Hi-Fi Products
Service Bulletin

Model: CDP-C910/C90ES

No. 245

Subject: Disc Stops Between Magazine and MD Mechanism

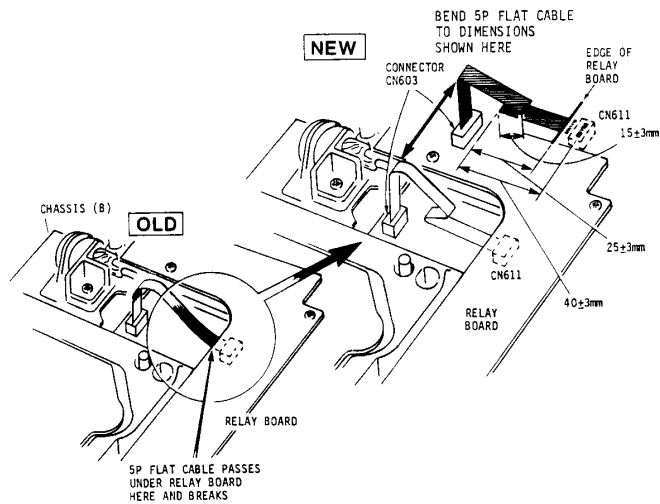
The disc stops between the magazine and the MD Mechanism due to flat Cable 5P which breaks. Cable 5P, which connects CN603 of M2 Motor Board and CN611 of the relay board passes under the relay board and breaks.

Solution: Replace flat Cable 5P with the new type (P/N shown below) and connect it after bending as shown below:
